STATE OF NORTH CAROLINA DEPARTMENT OF TRANSPORTATION

Addendum No. 2

RE: Contract ID: C201568 WBS# 34981.3.3 F. A. # STP-1158 (4) Wilson County (U-3823A) SR-1158 (Airport Blvd.) From 0.2 Miles NE of NC-42 To 0.4 Miles SW of US-264A

WETLAND DRAWINGS

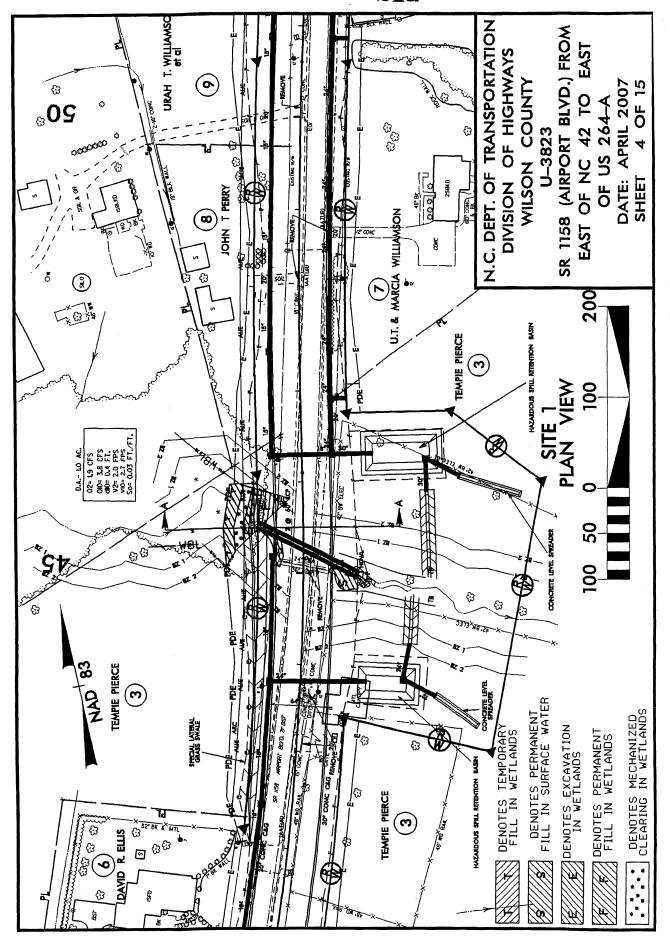
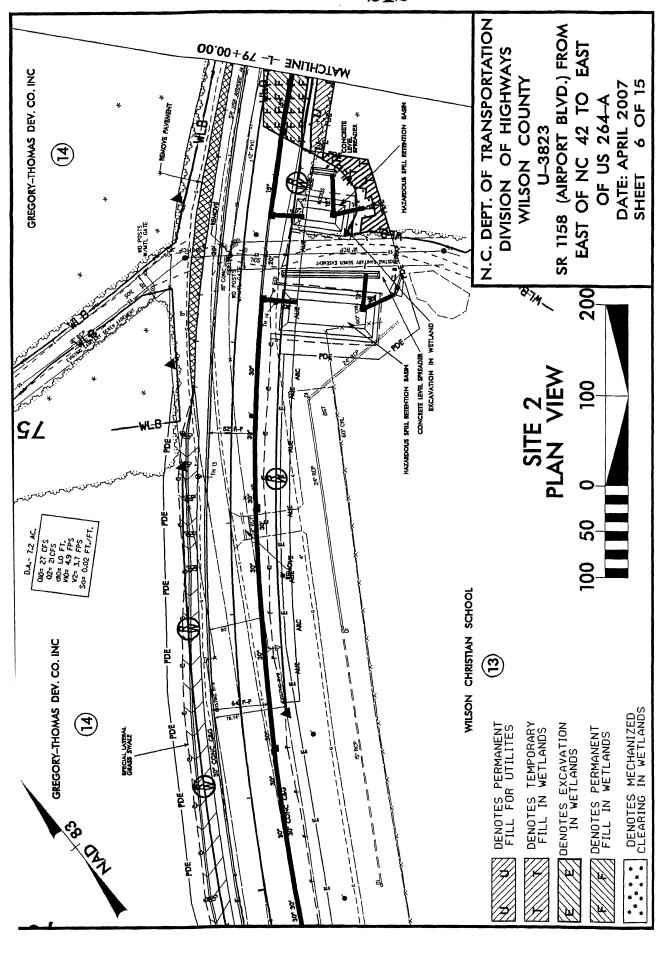
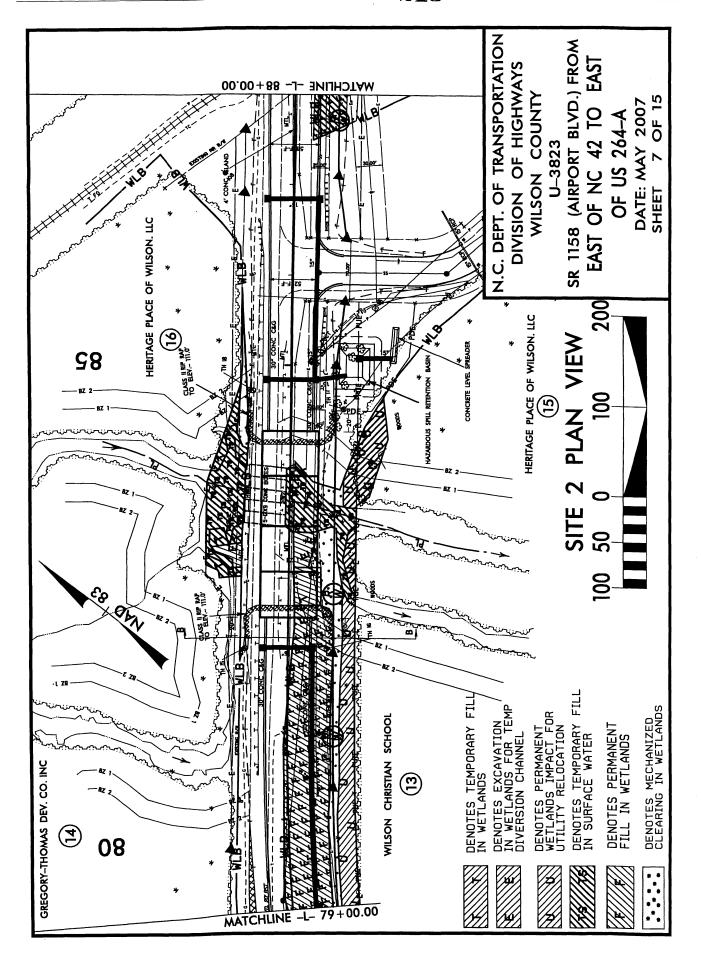
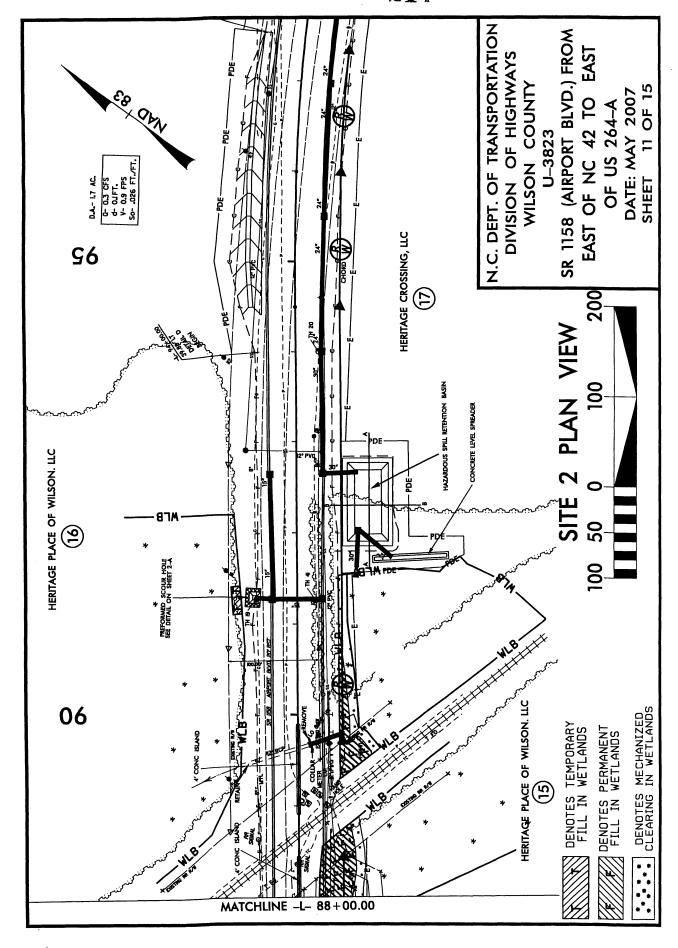
Site 2 (77+25-91+55 –L-)

Due to a re-evaluation of the construction and phasing methods for the removal of the box culvert and replacement with a bridge, along with the relocation of utility and railroad signal control boxes, an increase to wetland impacts has occurred at this site.

NCDOT continues to propose to remove the 12'x 9' pentuple barrel culvert, and replace it with a 4-span, 205-foot cored slab bridge carrying Bloomery Swamp. However, to allow for a cleaner and expedited removal of the existing box culvert, NCDOT will remove the entire culvert at one time. To accommodate this removal, the total permanent impacts to wetlands have increased as shown in Table 1 below, and in the attached drawings.

Table 1: Summary of Changes to Wetland Impacts at Site 2

Permanent Fill in Wetlands (ac)	Excavation in Wetlands (ac)	Mechanized Clearing in Wetlands (ac)	Temp Fill in Wetlands (ac)	Temp Fill in Surface Water (workpad) (ac)
Previously Permitted Impacts	0.547	0.001	0.299	0.118	0.066
Requested Modification	0.585	0.032	0.268	0.132	0.175
Difference	+0.038	+0.031	-0.031	+0.014	+0.109

BUFFER DRAWINGS

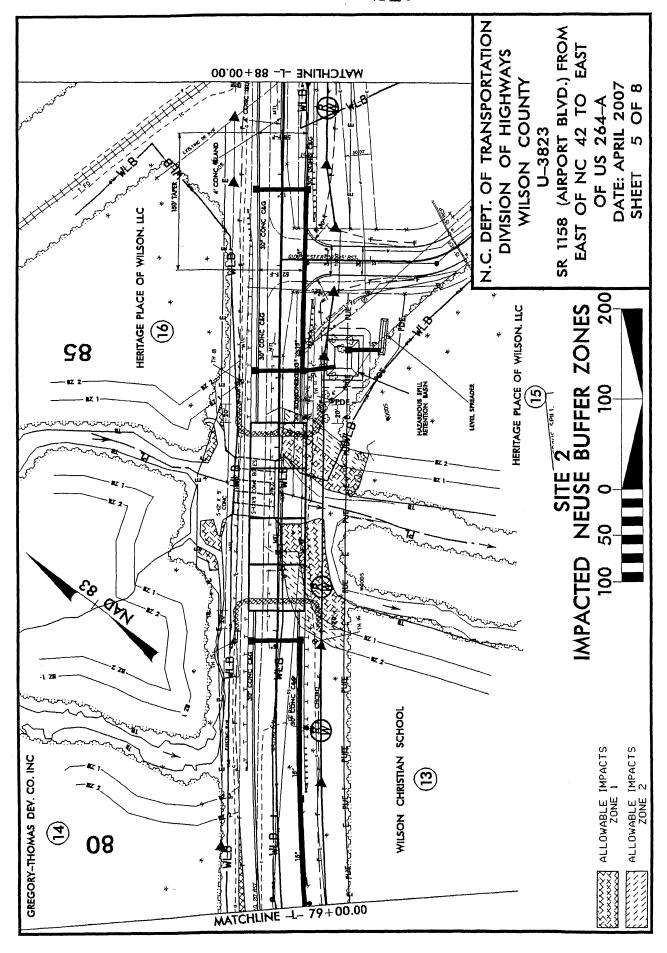
These proposed activities have also increased the impacts to the Neuse River Riparian Buffer as summarized in Table 2 below, and shown in the attached drawings. These proposed buffer impacts are considered allowable due to bridging.

Table 2: Summary of Changes to Buffer Impacts at Site 2

Zone 1 Impacts (sq. ft.)	Zone 2 Impacts (sq. ft.)
Previously Permitted Impacts	7,871	5,029
Requested Modification	8,535	5,525
Difference	+664	+496
